ADDENDUM NO. SIX

DATE: August 29, 2016
DEPARTMENT: Internal Services Department (ISD)
ISD PROJECT NAME: Renovation of the Culmer/Overtown Neighborhood Service Center
ISD PROJECT NUMBER: Z000120
BID DUE DATE: September 28, 2016 (REVISED)
CONTRACTING OFFICER: Fernando V. Ponassi, MA Arch., LEED® AP

**CULMER COMMUNITY RESOURCE CENTER**  
 PROPOSED ROOF WALK-WAY PATHS (EXHIBIT 2.3)

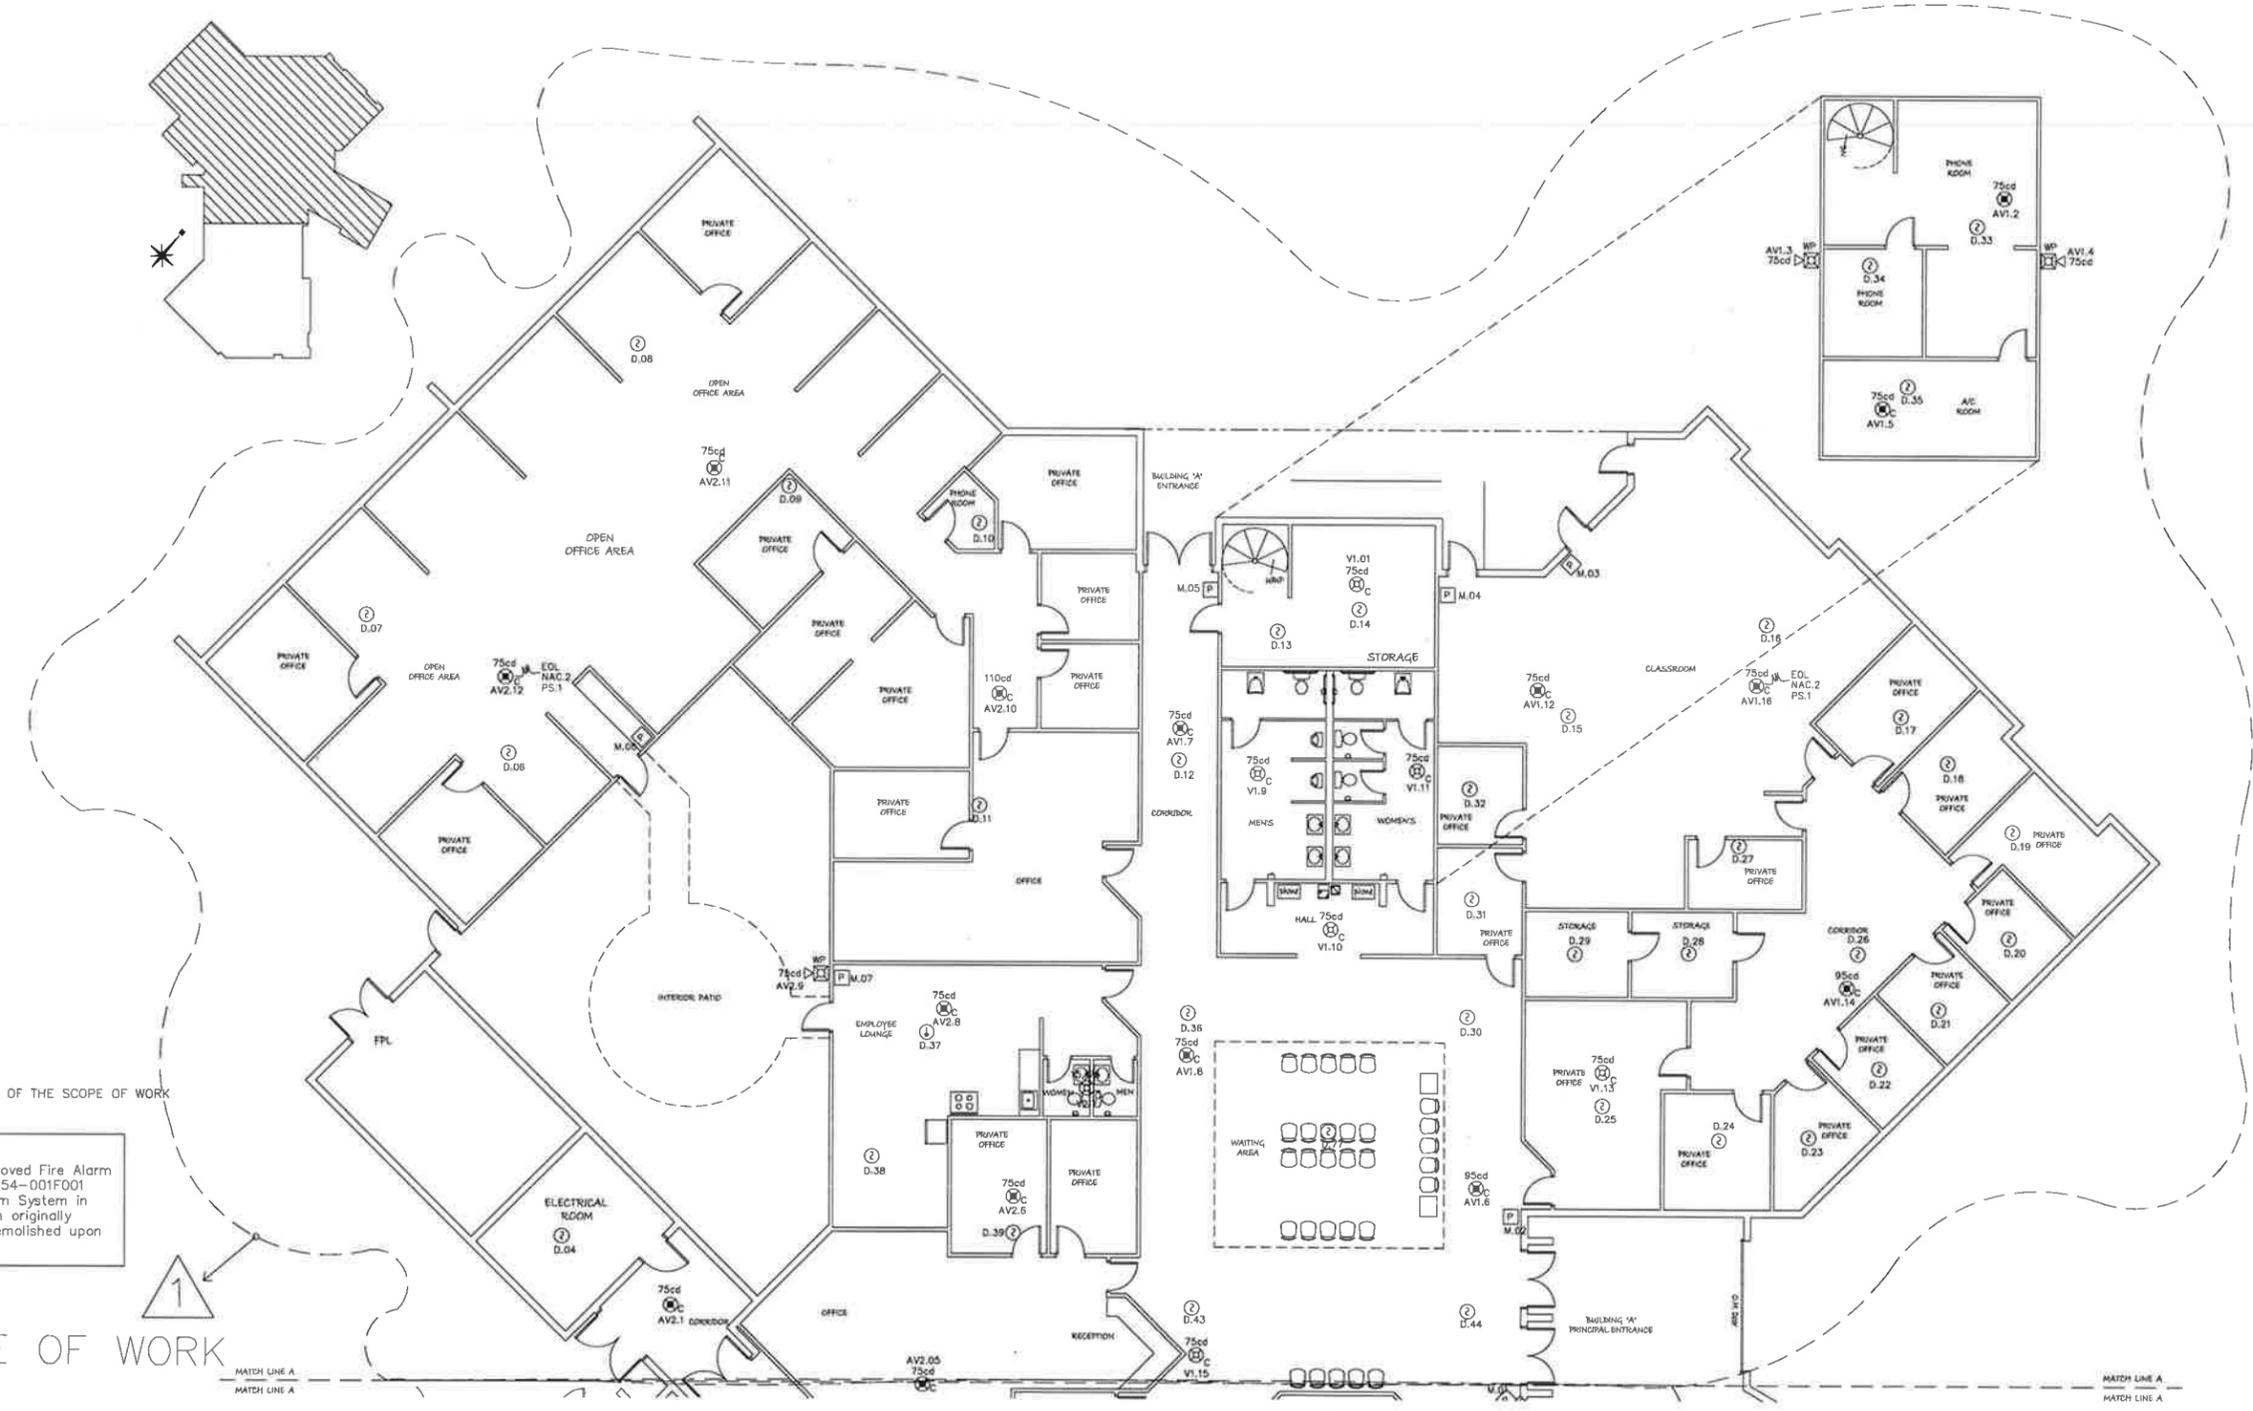
- 1. The bid due date has been extended to Wednesday, September 28, 2016, at 2:00 p.m. The place for submission of bids remains as originally advertised.
2. Exhibit 2 is hereby included to further complement a response to Q. 18-7, in Addendum No. 5 issued on August 3, 2016.
